December 2016
FL727A
NHTSA #16V-809

Subject: FCCC Motorhome Power Steering Hose Routing

Models Affected: Specific Freightliner Custom Chassis XBR, XCL, XCM, and XCR chassis equipped with Cummins ISL engines, and manufactured January 1, 2016, through October 13, 2016.

Fig. 1, Power Steering Hose with P-Clip (body removed for clarity)

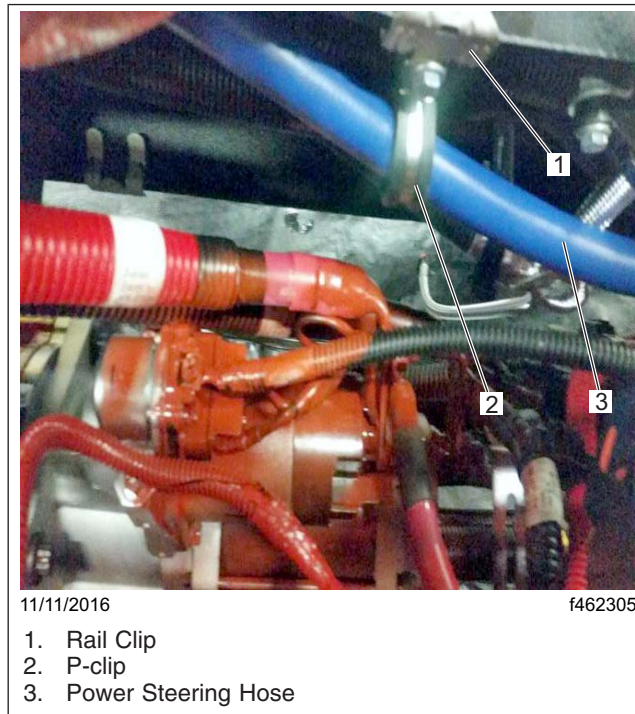
On certain motorhome chassis, the high pressure power steering hose may be routed with inadequate clearance between the hose and a power stud on the starter motor. This may cause the hose to chafe against the power stud on the starter, potentially leading to arcing and, in addition, may cause loss of fluid, short circuit, and melting. Electrical arcing in the presence of leaking power steering fluid can increase the risk of a fire.

The high pressure power steering hoses will be rerouted to provide adequate clearance from the starter stud.

1. Install a rail clip on the top flange of the frame rail, just above the starter.
2. Using a P-clip, bolt, nut, and washer, secure the power steering hose on the rail clip. See [Fig. 1](#). Tighten the nut 72 lbf-in (813 N-cm).
3. For additional security, install tie bands around the hose to the harness near the frame rail within 18 inches (46 cm) of the P-clip.
4. Clean a spot on the base label (Form WAR259). Write the recall number, FL727, on a completion sticker (Form WAR260), and attach it to the base label.
